# A428 Black Cat to Caxton Gibbet improvements

9.67 Applicant's comments on Cambridgeshire County Council's  
response to WQ2.11.2.1

**9.67 Applicant's comments on Cambridge County Council's  
response to WQ2.11.2.1**

<b>Regulation Reference:</b>	Rule 8(1)(k)
<b>Planning Inspectorate Scheme Reference</b>	TR010044
<b>Application Document Reference</b>	TR010044/EXAM/9.67
<b>Author</b>	A428 Black Cat to Caxton Gibbet improvements Project Team, National Highways

## B-1 Key Plan: B1040 Potton Road

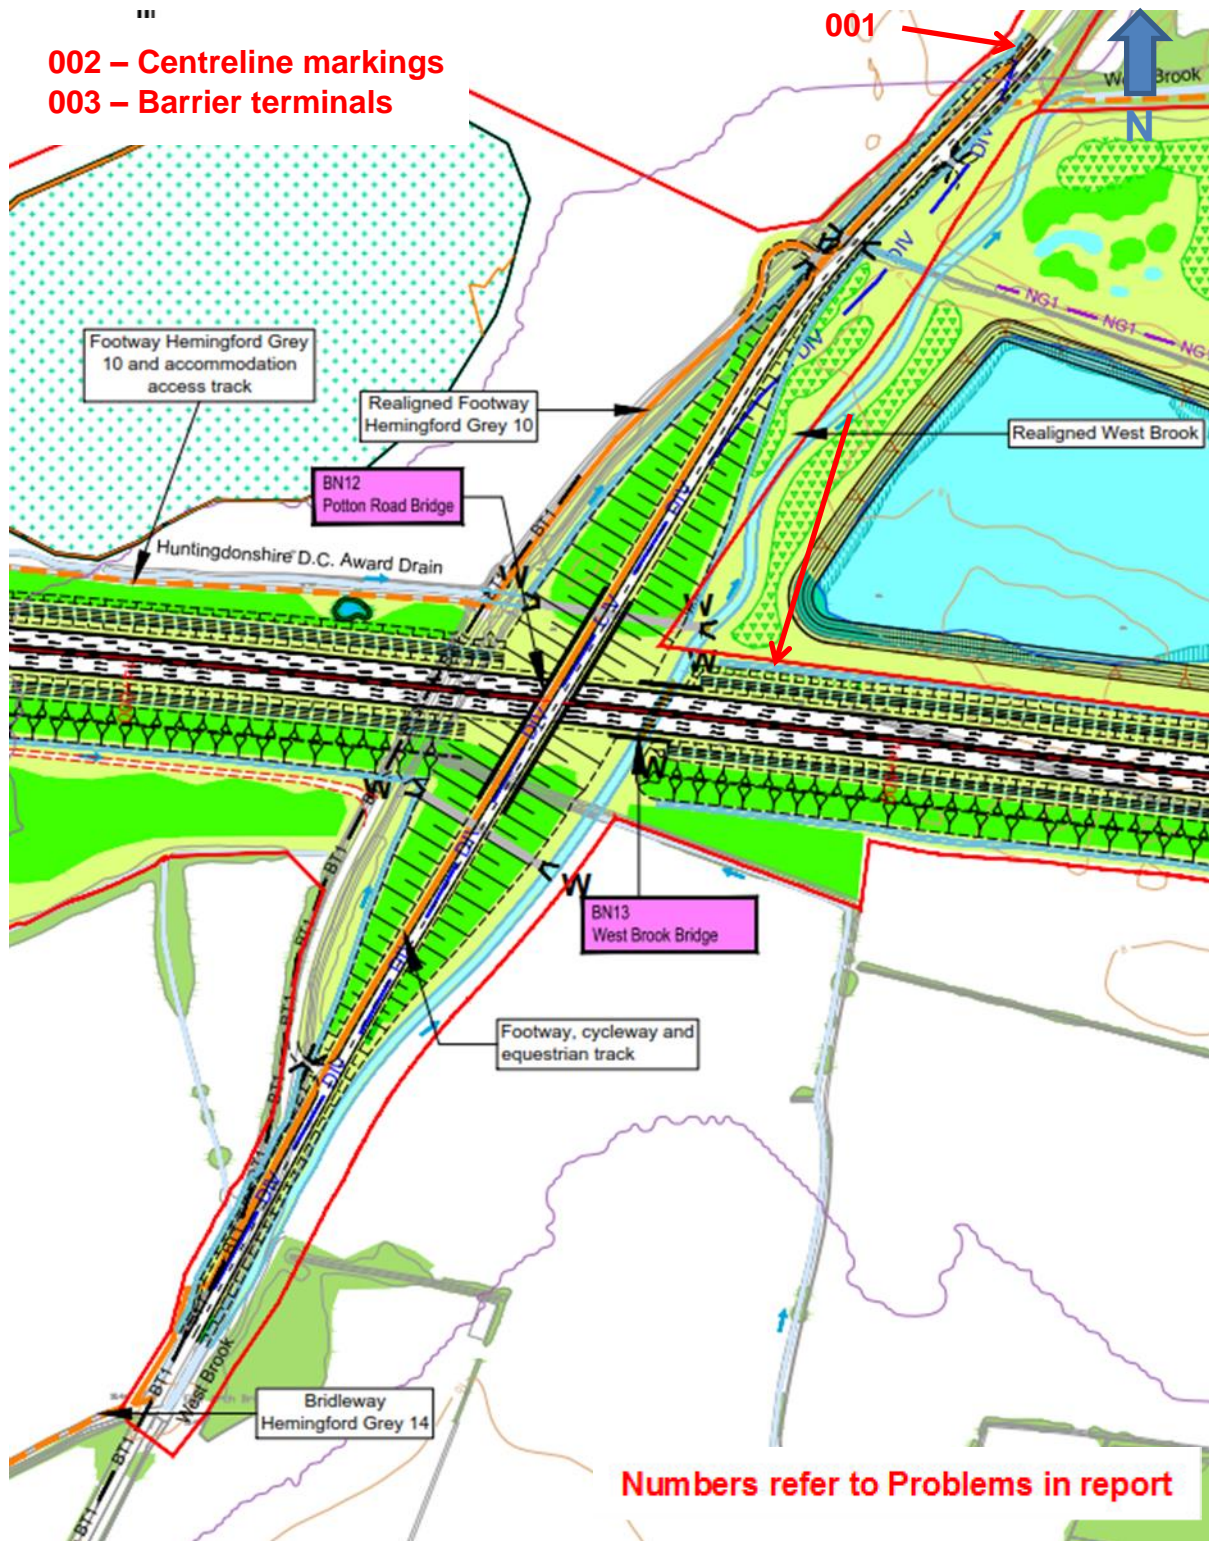
#### Photo 3: Potton Road, example of barrier terminal detail

It is recommended that the barrier terminals (on both sides and in both directions) are provided with a reflectorised (black / yellow diagonal detail) hazard plate.

B-1: Key Plan: Conington Road Overbridge - Sheet 1 of 3	20
B-2: Key Plan: Conington Road Overbridge - Sheet 2 of 3	22
B-3: Key Plan: Conington Road Overbridge - Sheet 3 of 3	24

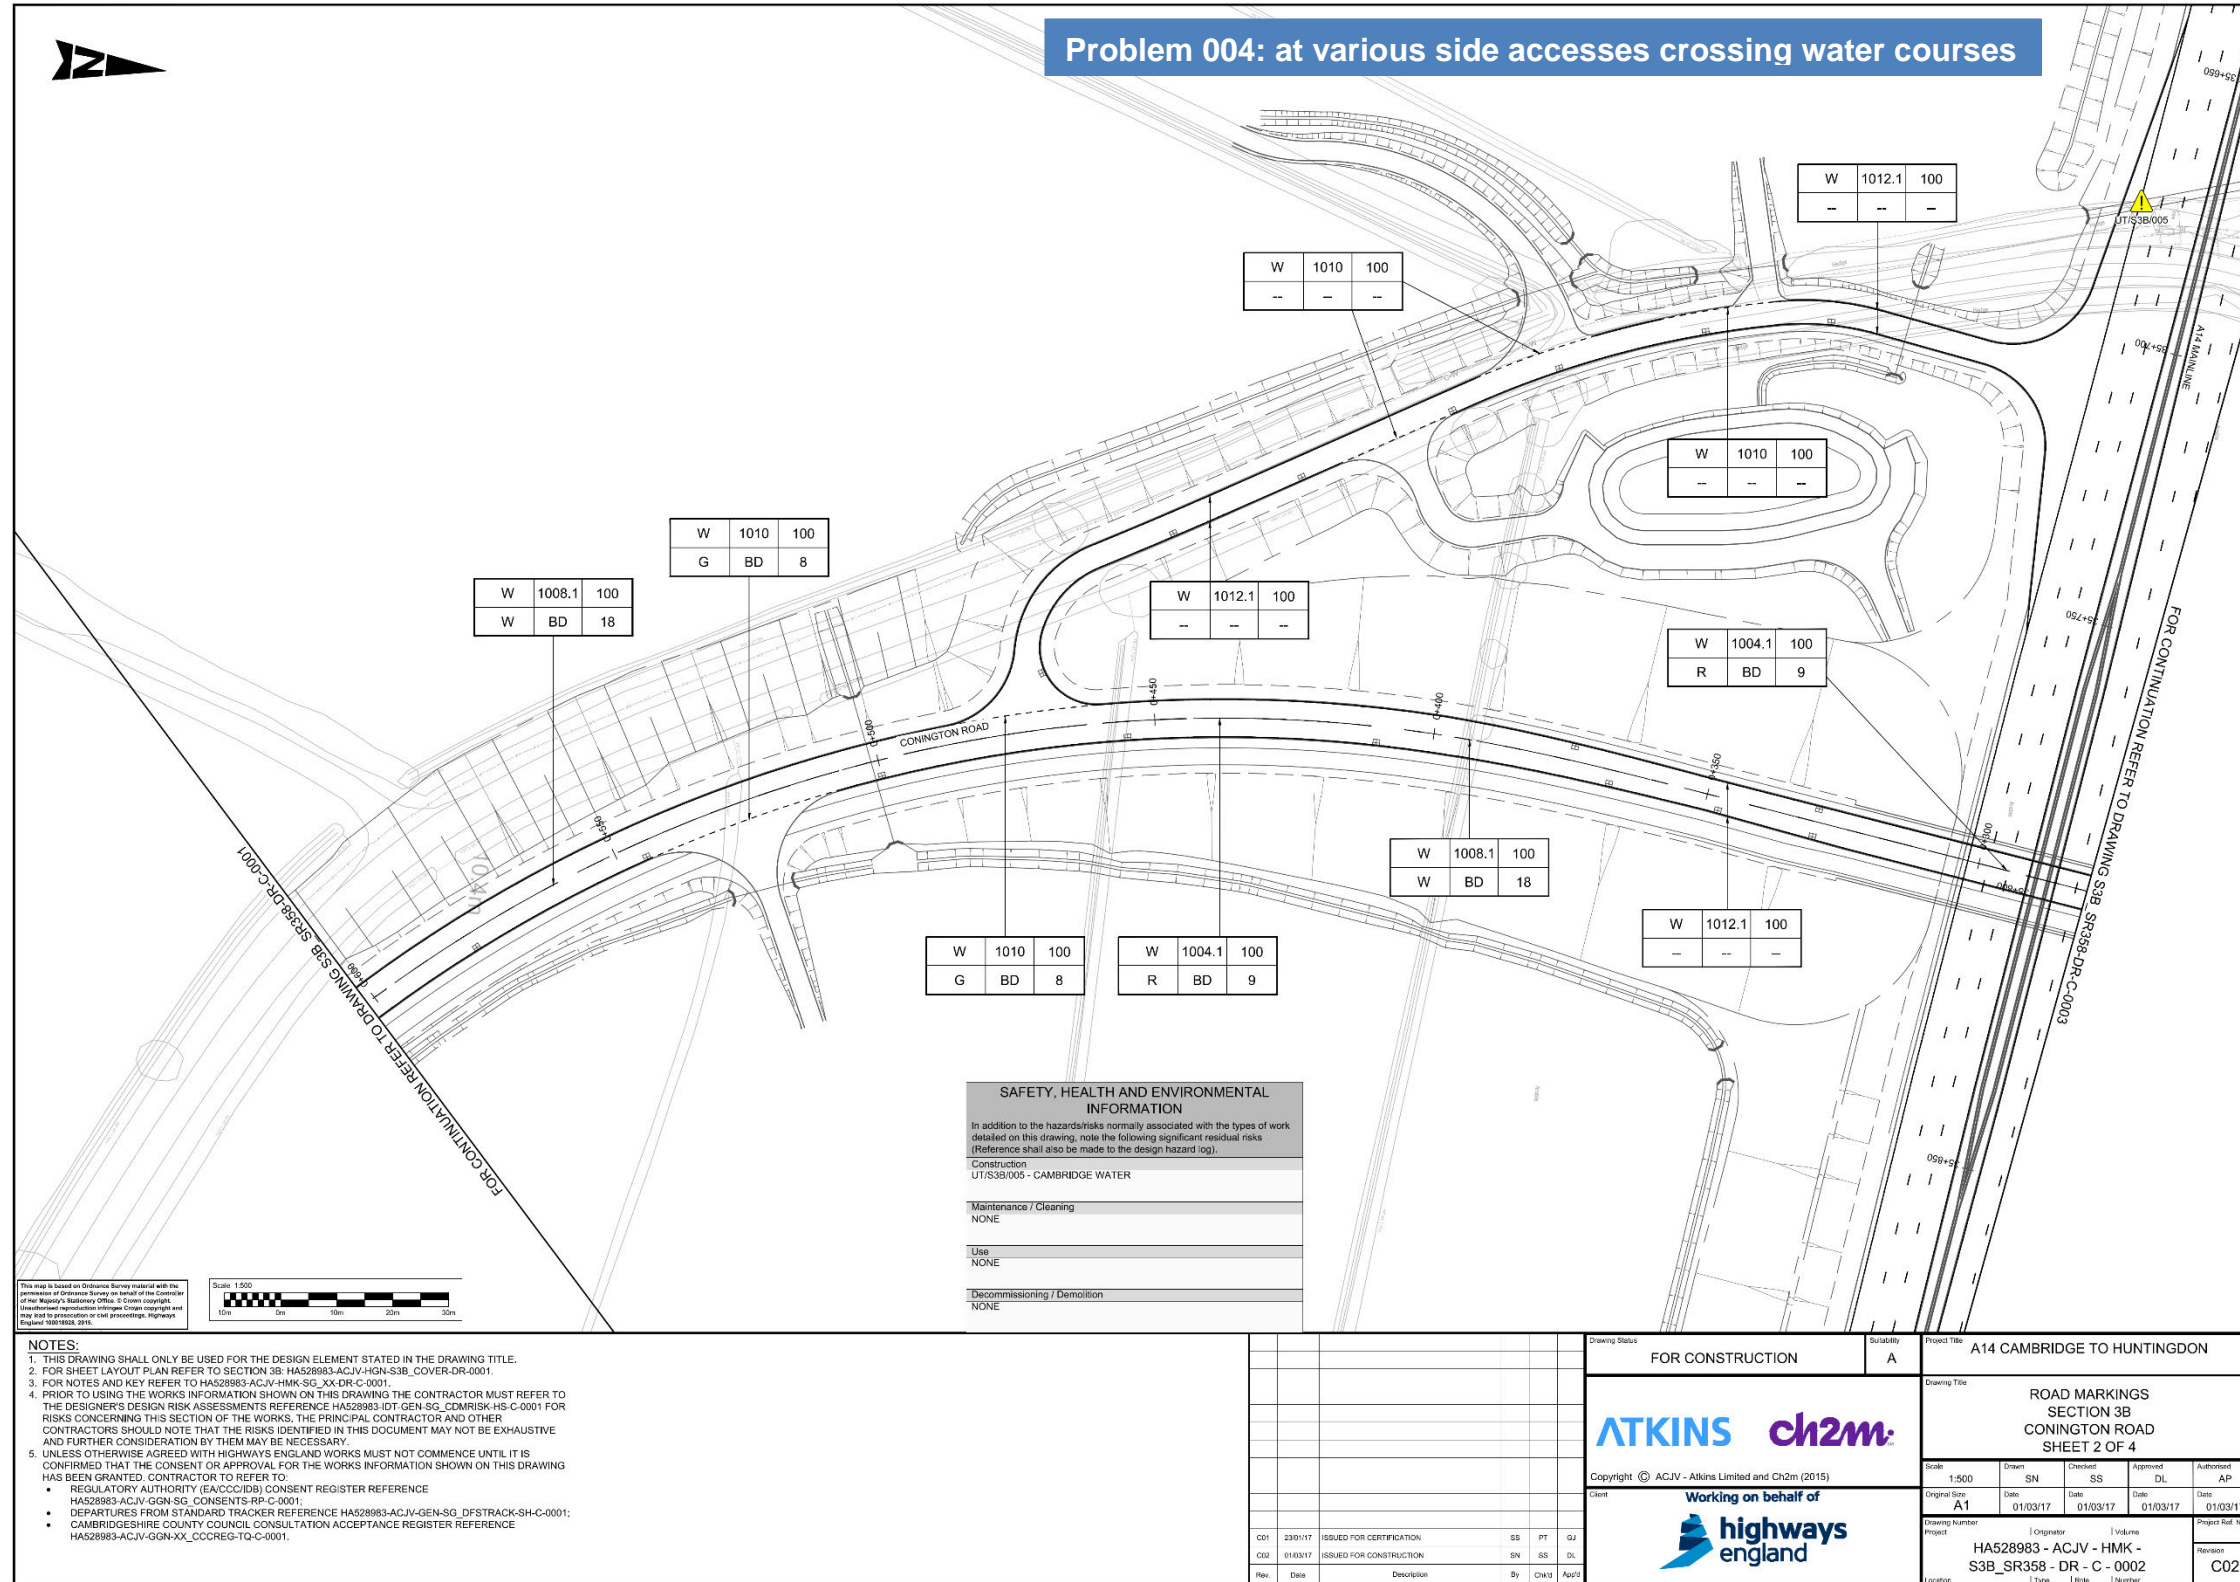
Ref:	Location and Identified Issue	Response Comment / Action
001	<p><b>Northbound approach to Conington Road overbridge, from Conington Village.</b></p> <p><b>Use of deflection arrow markings to reinforce no overtaking markings.</b></p> <p><i>On the northbound approach to Conington Road, there are currently only two deflection arrow markings provided prior to the commencement of the double white lines in place (to prohibit overtaking).</i></p> <p><i>The Audit Team is of the opinion that due to the alignment of the carriageway in advance of the double white line system and propensity for vehicle speeds to increase as the cross-section improves that inappropriate overtaking manoeuvres may result, increasing the risk of head-on collisions.</i></p> <p><b>Recommendation</b></p> <p><i>It is recommended that a third deflection arrow (to TSR&amp;GD Dia.1014) is provided on this approach.</i></p>	<p><b>Designers Response - Accepted</b></p> <p><i>Agree -the drawings are to be reviewed and amended as needed.</i></p> <p><b>Follow-up Action</b></p> <p>-</p> <p><b>Audit Team Comment at RSA3</b></p> <p>The Audit Team considers this matter to be outstanding.</p>

002	<p><b>Conington Road – southbound (at approximate Chainage 0+650).</b></p> <p><b>Warning of change in carriageway cross-section.</b></p> <p><i>On the southern section of Conington Road, as the cross-section reverts to a narrower and more rural environment, the Audit Team is of the opinion that drivers southbound may be prone to conflicts with oncoming vehicles, which in turn may result in heavy braking, vehicles mounting the verge or colliding with approaching vehicles.</i></p> <p><b>Recommendation</b></p> <p><i>It is recommended that a new ‘Road narrows on both sides ahead’ warning sign (to TSR&amp;GD Dia.516) is provided, in conjunction with a new ‘SLOW’ carriageway marking on the approach to the change in cross-section (southbound).</i></p> <p><i>For further guidance regarding the siting and sizing of this sign, refer the Traffic Signs Manual, Chapter 4 Warning Signs.</i></p>	<p><b>Designers Response - Accepted</b></p> <p><i>Agree -the drawings are to be reviewed and amended as needed.</i></p> <p><b>Follow-up Action</b></p> <p>-</p> <p><b>Audit Team Comment at RSA3</b></p> <p>The Audit Team considers this matter to be outstanding.</p>

Ref:	Location and Identified Issue	Response Comment / Action
003	<p><b>Conington Road – western side, northbound approach to overbridge.</b>  Length of VRS protecting embankment.</p> <p>The Audit Team is concerned as to the length of vehicle restraint system (VRS) on the western side of the structure, for northbound vehicles. The alignment comprises a right-hand bend for northbound vehicles and there is a significant batter slope which, in the opinion of the Audit Team, is considered to be an increased risk of injury severity to the occupants of errant vehicles descending.</p> <p><b>Recommendation</b>  It is recommended that the VRS on the western side of the structure be extended towards the proposed maintenance access.</p> <p>This should be cognisant of the visibility requirements for the access, covered by TD 41/95 'Vehicular Access to All Purpose Trunk Roads'.</p>	<p><b>Designers Response - Accepted</b>  Agree – A review of the RRRAP will be undertaken to determine the need. The drawings are to be reviewed and amended as needed.</p> <p><b>Follow-up Action</b>  -</p> <p><b>Audit Team Comment at RSA3</b>  The Audit Team considers this matter to be outstanding.</p>

Ref:	Location and Identified Issue	Response Comment / Action
005	<p><b>Conington Road, southbound (approximate Chainage 575m). Delineation of centre line.</b></p> <p><i>The warning line between approximate Chainage 460m and 550m comprises a 1004.1 marking. Beyond this, it reverts to a standard lane line.</i></p> <p><i>The Audit Team is of the opinion that road users may not fully appreciate both the presence of the bend and the proximity of side road accesses throughout this section. This has the potential to result in drivers negotiating this section at inappropriate speeds, which in turn could lead to loss of control collisions or conflicts with turning vehicles.</i></p> <p><b>Recommendation</b></p> <p><i>It is recommended that a longer warning line between approximate Chainage 550 and 600m is provided, such that it extends beyond the access on the western side of Conington Road.</i></p>	<p><b>Designers Response - Accepted</b>  <i>Agree - the drawings to be amended as necessary.</i></p> <p><b>Audit Team Comment at RSA3</b>  The Audit Team has no further comments regarding this issue.</p>

Ref:	Location and Identified Issue	Response Comment / Action
007	<p><b>Field Access crossings – protection of culverts.</b>  <b>Protection for headwalls.</b>  <i>At the eastern drain at the field access crossings there are headwalls which have no protection to prevent pedestrian falls into them. This can result in an increased risk of fall injuries to pedestrians.</i></p> <p><b>Recommendation</b>  <i>It is recommended that appropriate protection for culvert headwalls on the eastern drain at field access crossings ('kee-klamp' or similar) is provided.</i></p>	<p><b>Designers Response - Accepted</b>  <i>Agree – From the photo it is clear that some details are yet to be constructed. The IFC drgs will be reviewed and amended as necessary to ensure appropriate protection for culvert headwalls is made.</i></p> <p><b>Audit Team Comment at RSA3</b>  The Audit Team considers this matter to be outstanding.</p>
